Australian Air Publication 721.79

# VAMPIRE MODIFICATIONS

(Nos 401 to 500)

Attachments: Drawing A15401-1

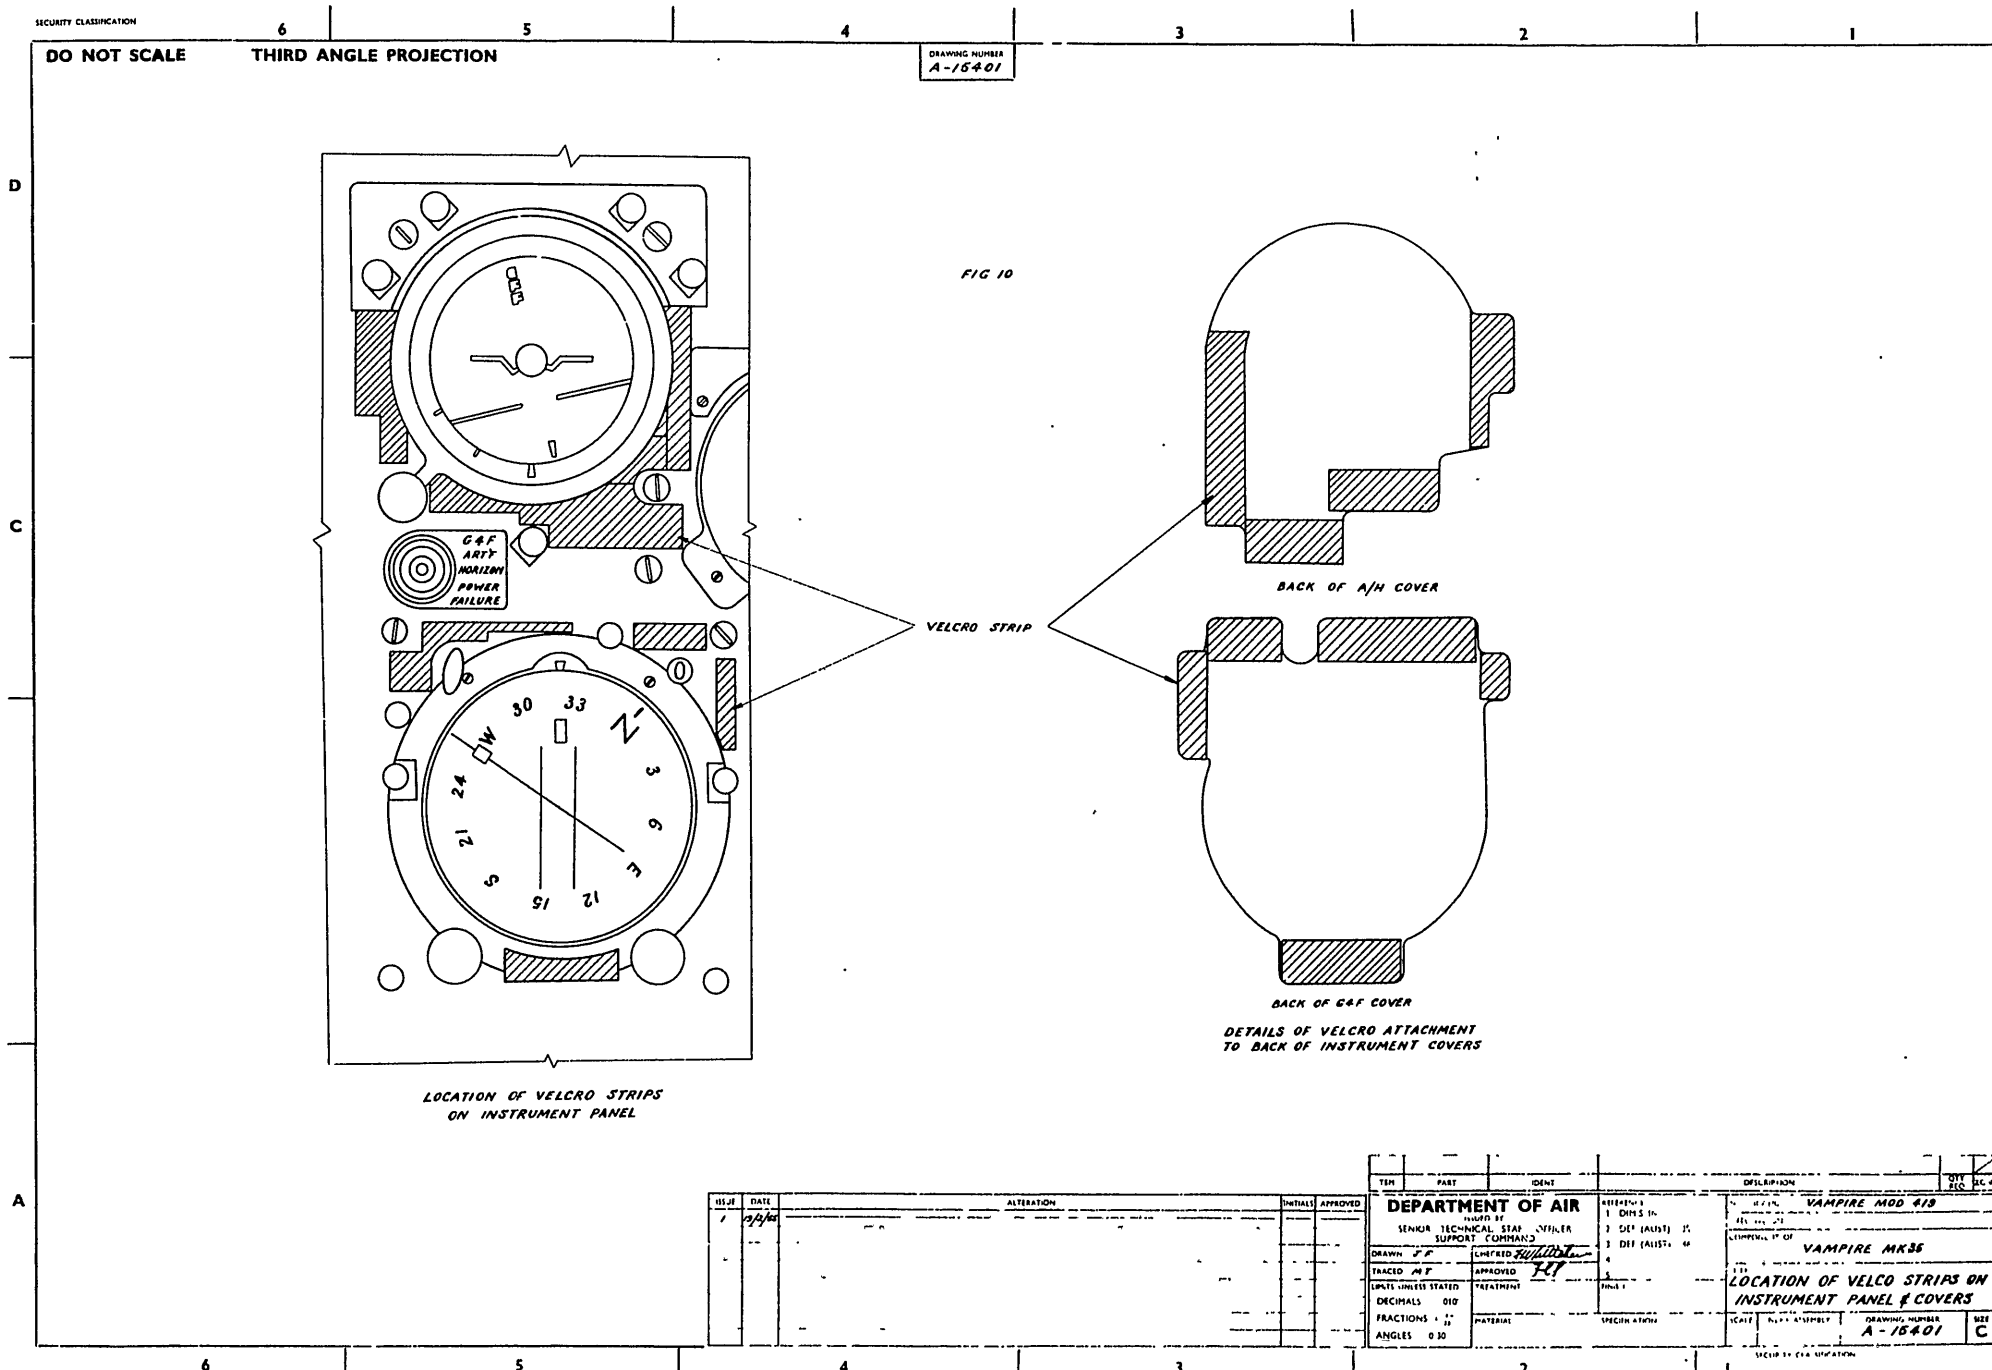
12. (a) Using the hook portion of item 1 attach it to the instrument panel, as detailed in Drawing A15401, with item 5 adhesive.
- Note: Apply a minimum amount of pliobond to the desired areas and allow them to nearly dry before bringing them together.

- (b) Cut item 2 to the shapes detailed in Drawing A15401, trimming each piece individually to fit the panel over the instruments.
- (c) Using item 5 attach the "wool tuft" portion of item 1 to item 2, as detailed in the drawing.

- (g) Using items 6 to 10, manufacture a stowage bag as detailed in Drawing A15401.
- (h) Using items 11 and 12 attach the stowage bag to the starboard cockpit wall.

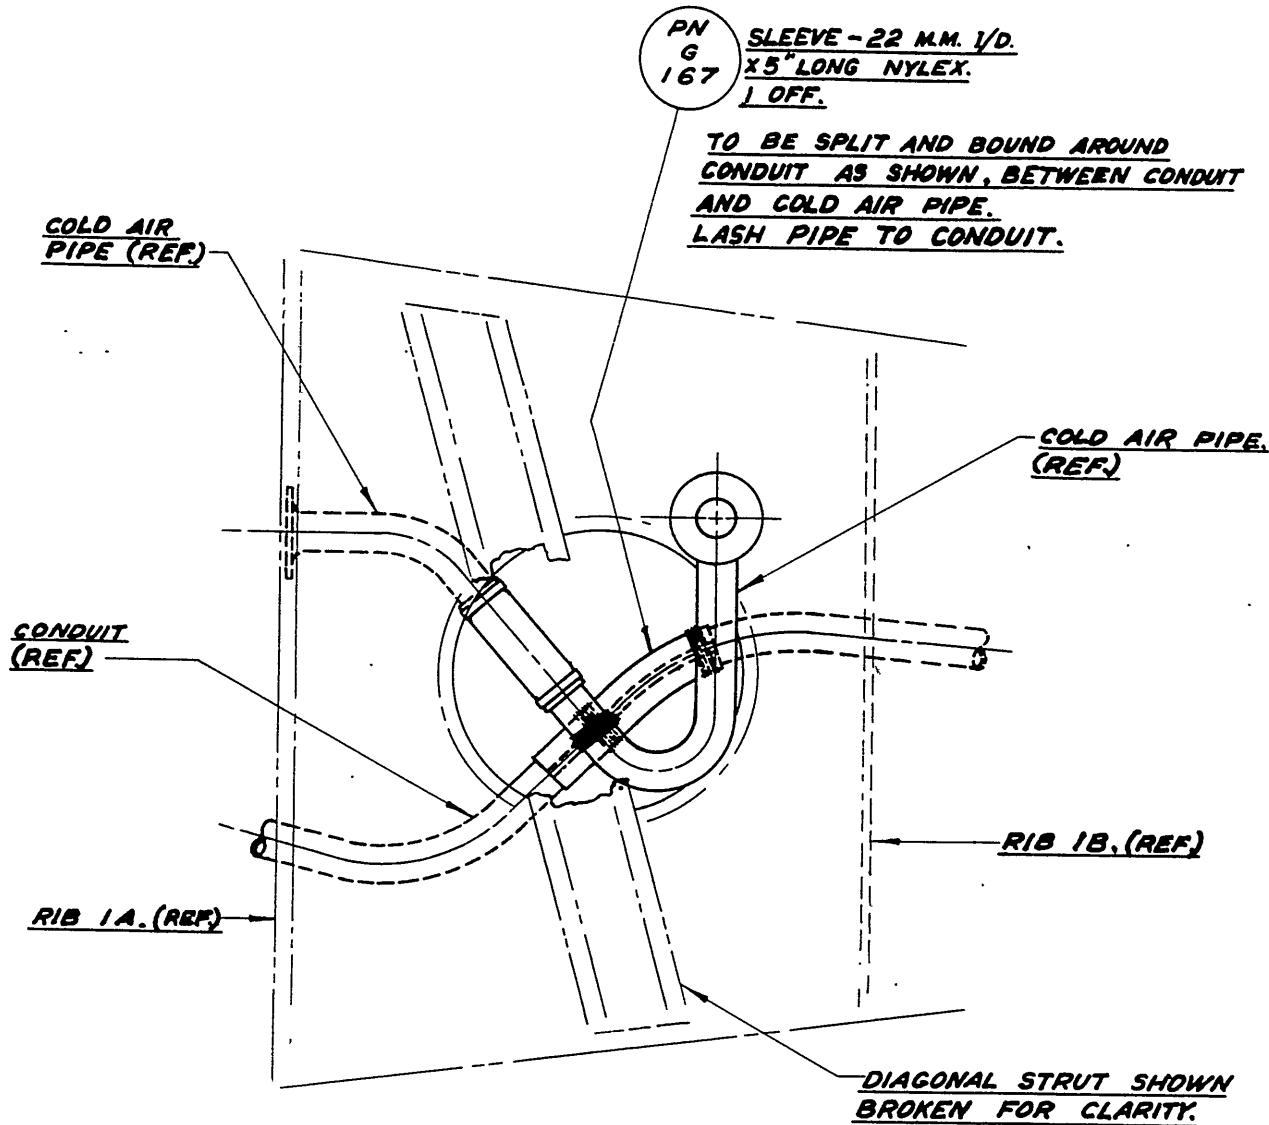
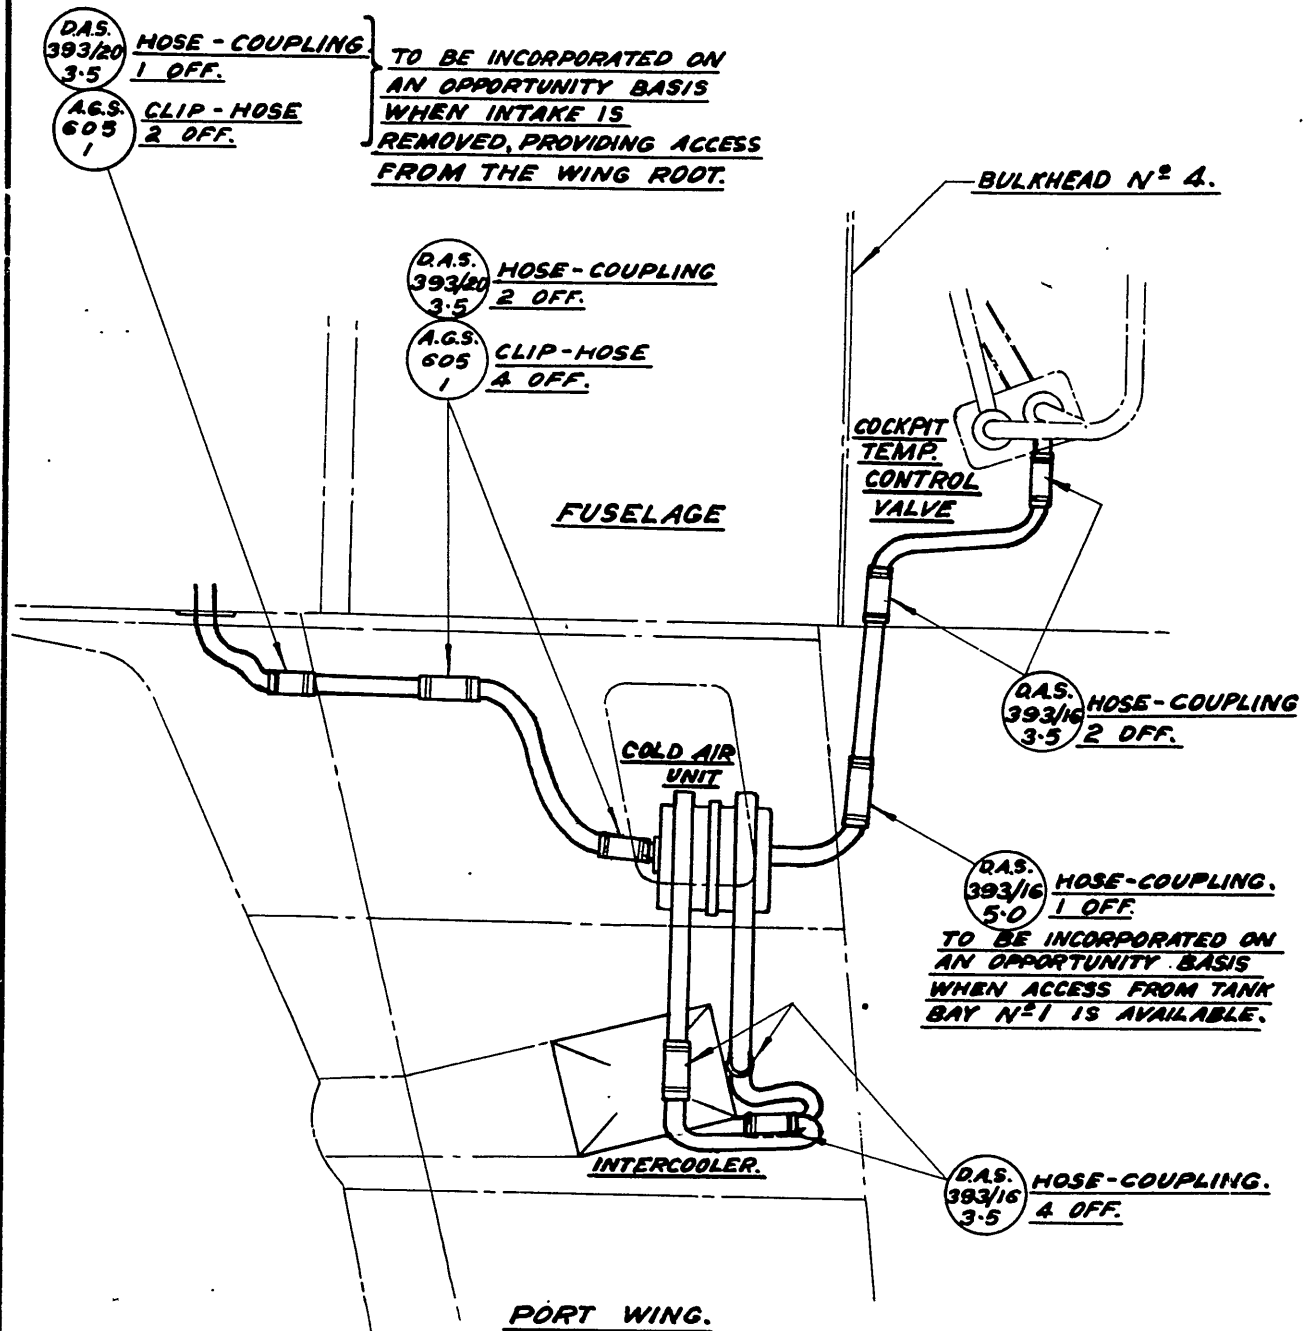
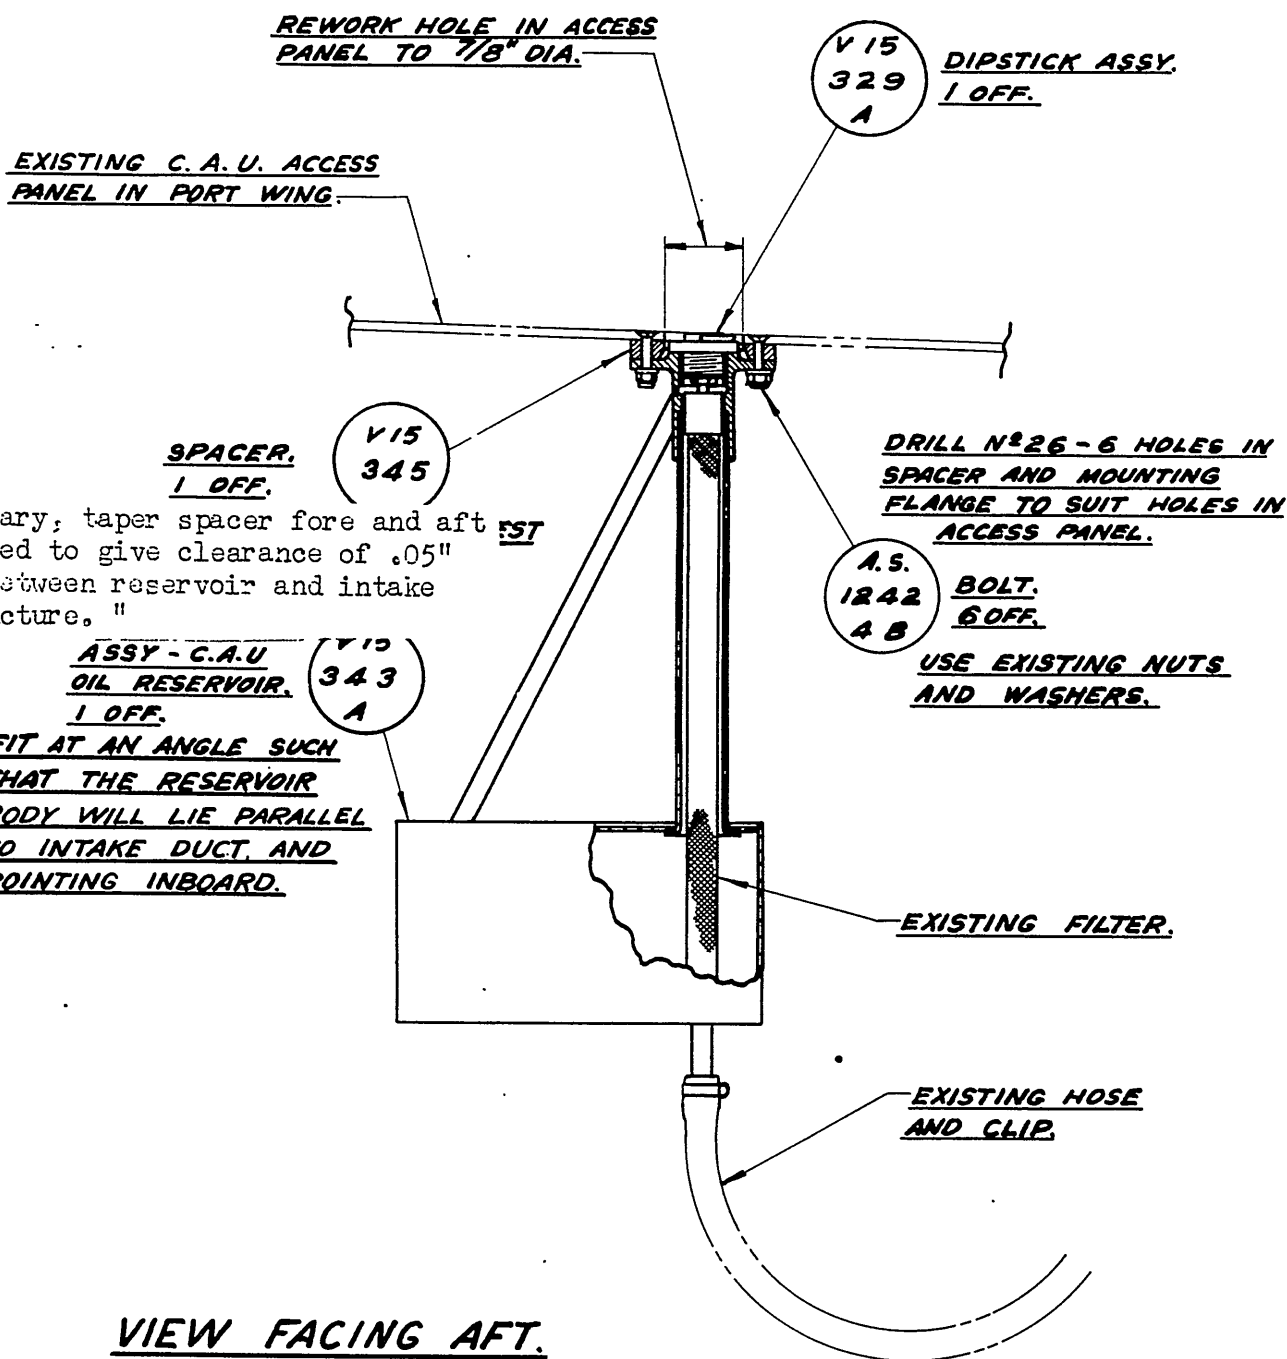
12. (a) Remove CAU access panel complete with oil reservoir from port wing.
- (b) Remove CAU from wing - AAP 721.79, Vol 1, Sect 3, Chap 8.
- (c) Remove upper engine inspection doors.
- (d) Split nylex sleeve (item 8) and bind to conduit using waxed cord (items 9 and 10) as shown on sheet 1 of Drawing No A15888.

- (e) Replace coupling hoses (items 15, 16 and 2 off item 17) and hose clips (item 18) with coupling hoses (items 4 and 5) and hose clips (item 6) as shown on sheet 2 of Drawing No A15888.
- (f) Replace CAU in wing - AAP 721.79, Vol 1, Sect 3, Chap 8.
- (g) Remove CAU oil reservoir (item 11) and packing (item 12) from access panel.
- (h) Rework access panel and fit CAU oil reservoir (item 1) If necessary spacer (item 2) is to be 3 bolts (item 7) with tapered in the fore and aft direction as shown on sheet 3 of to obtain a minimum of .05" clearance between reservoir and air intake duct aw dipstick assembly (item 3). in wing. Restore finish on spacer after reworking. " replace access panel, ~~on reservoir in wing.~~
- (l) Fill the reservoir to correct level with engine oil OEP 71.
- (m) Replace upper engine inspection doors.
